**From:** John Lai  
**Sent:** Thursday, April 03, 2008 8:46 AM  
**To:** George Wunder  
**Cc:** Glenn Kelly; Hossein Hamzehee  
**Subject:** FW: Information from ABWR SSAR  
**Attachments:** 20\_03\_09.pdf

The attached file contains GE responses to the Ninth set of RAIs on the ABWR SSAR. Questions 725.43, 725.44, and 725.45 reference the transmittal of CAFTA and MAAP input files to the NRC. This is all of the additional information I have right now. I'm not sure of the dates of the RAI or the responses, although it was probably in the mid 90s.

### 20.3.9 Response to Ninth RAI — Reference 9

Figure 20.3.9-1 Water Level in Fuel Channels Following a 0.00202 m<sup>2</sup> Vessel Bottom Head Drainline Break: 1 RHR + 3 ADS Available

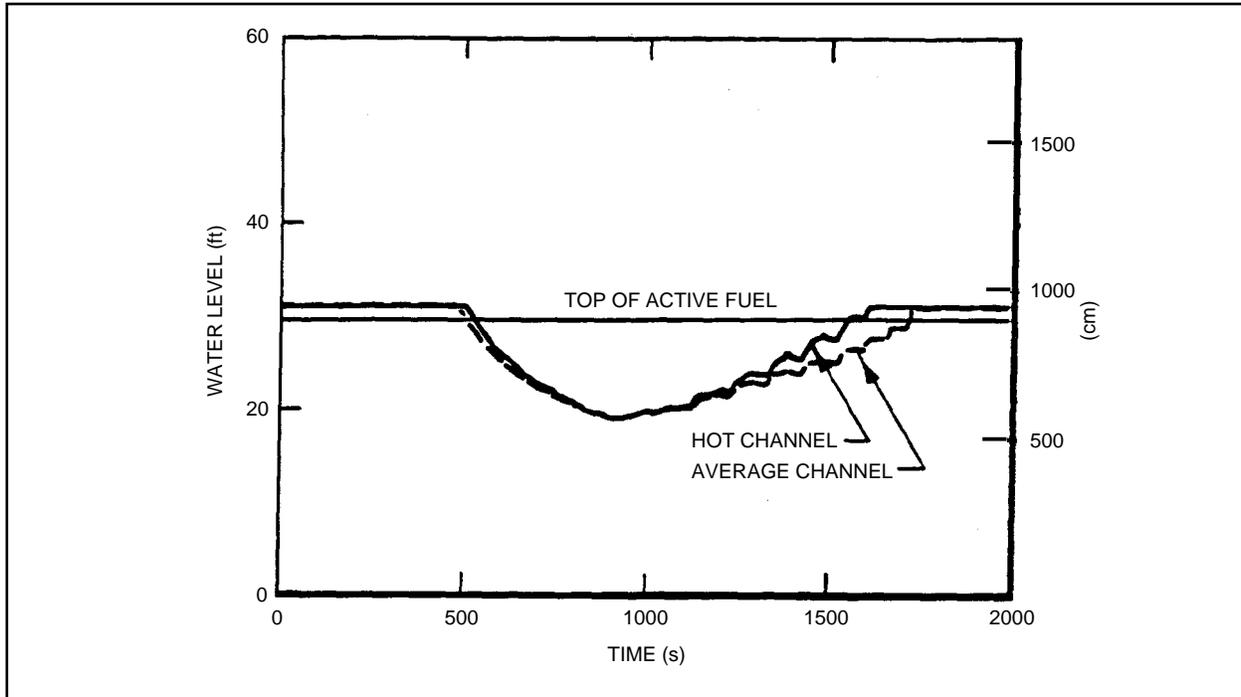
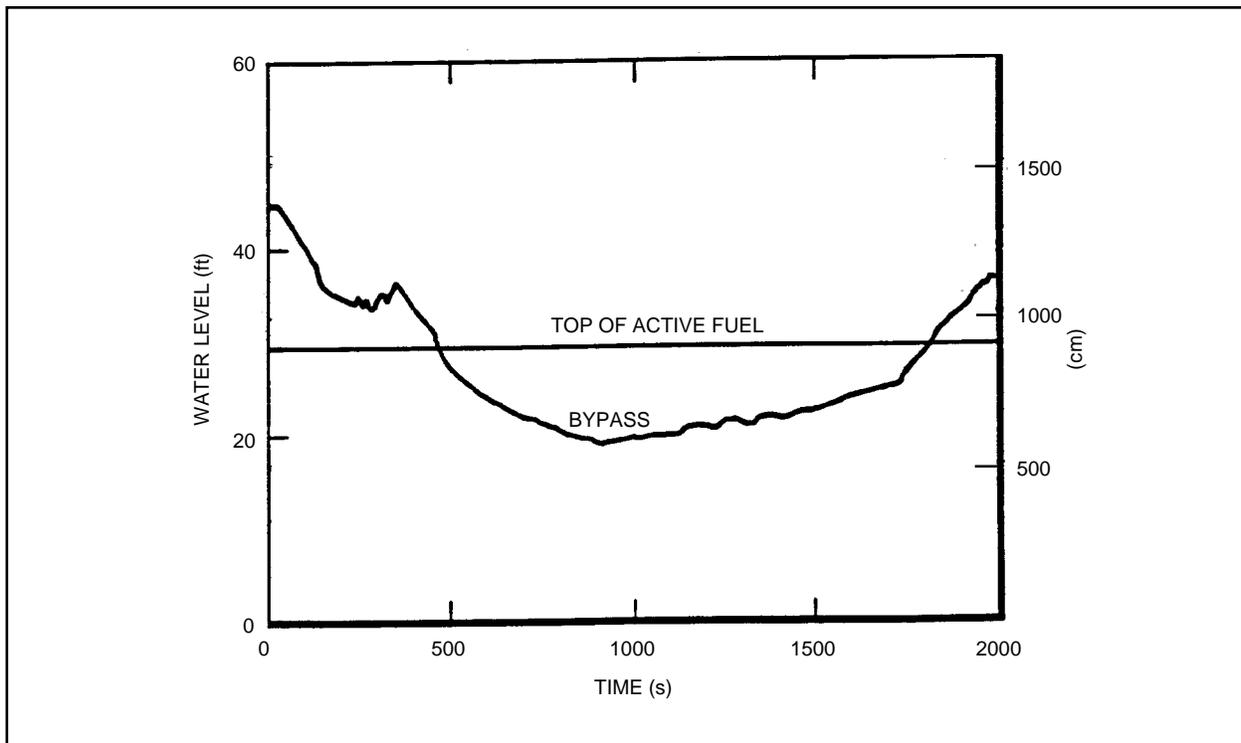
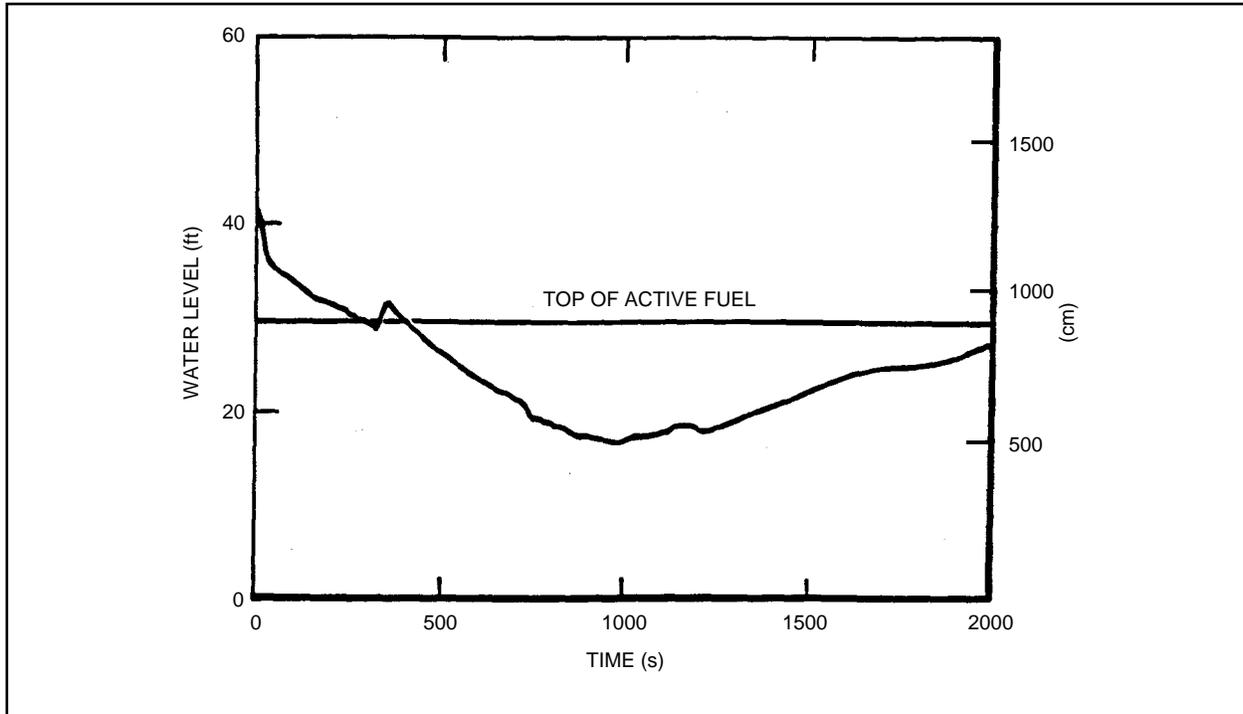
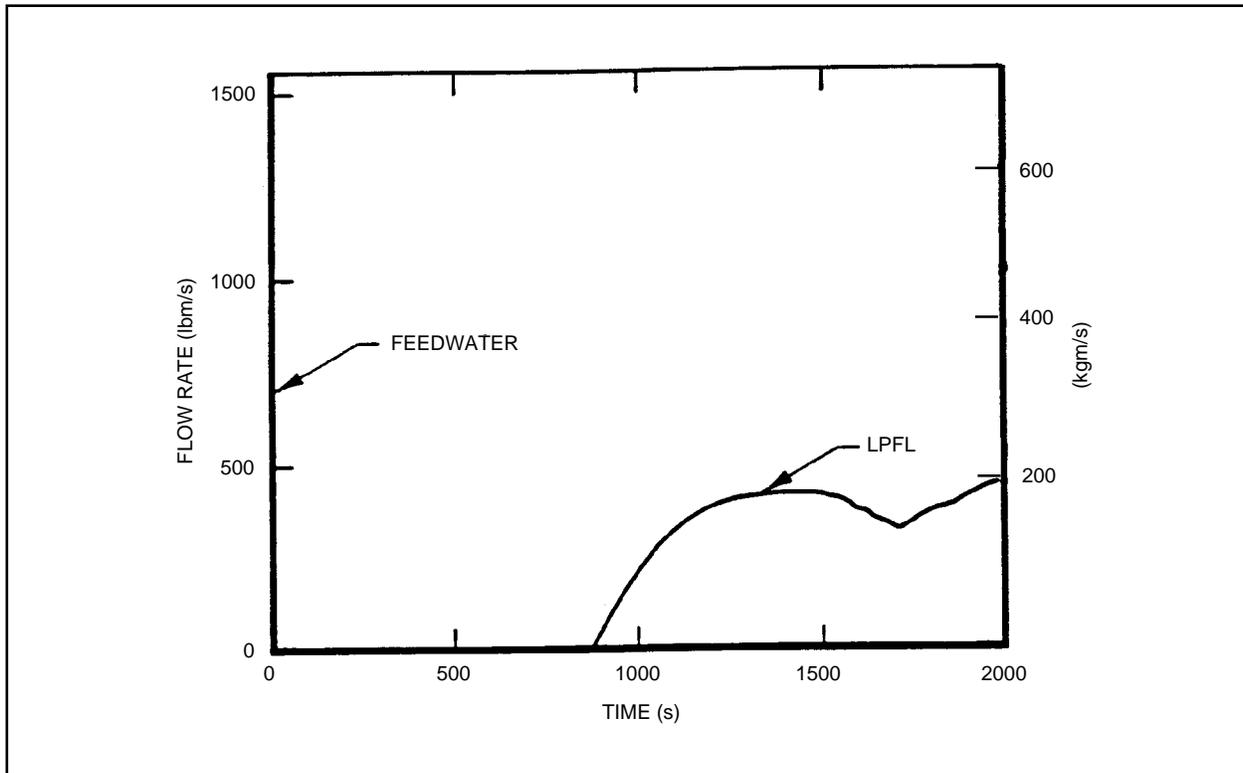
In essentially all of the event trees shown in Fig. 19D.4-1 through Fig. 19D.4-14, failure of the W function (long term heat removal) is assigned a probability of failing to run RHRA or RHRB or RHRC rather than failing to start and run RHRA or RHRB or RHRC, if the preceding V function (RHR injection or condenser) is a success. This would be correct if one of the RHR pumps was successfully started and run to accomplish the mission of the V function, and then switched to a long term heat removal mode. Notice, however that the success of the V function can also be achieved, as indicated in Table 19.3-2, by using one condenser pump and one condenser transfer pump. In such a case, the approach taken in the ABWR FSR will underestimate the failure probability of W since the RHR pump has to be started and then run throughout the mission time. Also, can one RHR pump alone always accomplish the missions of both the V and the W functions for all the transients including a large LOCA?

To determine that 1 RHR pump in the low pressure flooding mode is sufficient to perform the V function (i.e. core cooling) for any LOCA it was necessary to consider the complete spectrum of possible breaks. For the small and medium breaks, it was assumed that 3 ADS valves were also available to depressurize the vessel. For the large breaks, it was assumed that only the RHR pump is available since sufficient vessel depressurization occurs through the break. LOCA analyses for the success criteria were based on best-estimate predictions using the GE licensing approved computer models.

For small and medium breaks, it was determined that the maximum vessel bottom head drainline break ( $0.00202 \text{ m}^2$ ) was the most limiting case. This is the lowest possible break location on the vessel resulting in a high break flow throughout the transient. The LOCA analysis for this case resulted in a calculated peak cladding temperature (PCT) of  $966^\circ\text{C}$  which is well below the  $1204^\circ\text{C}$  limit. Important variables from this analysis are shown in Figures 20.3.9-1 through 20.3.9-7.

Based on the results of the above study, it was concluded that 1 RHR pump provides sufficient core cooling for large breaks, and also for small and medium breaks with the equivalent of at least 3 ADS valves available.
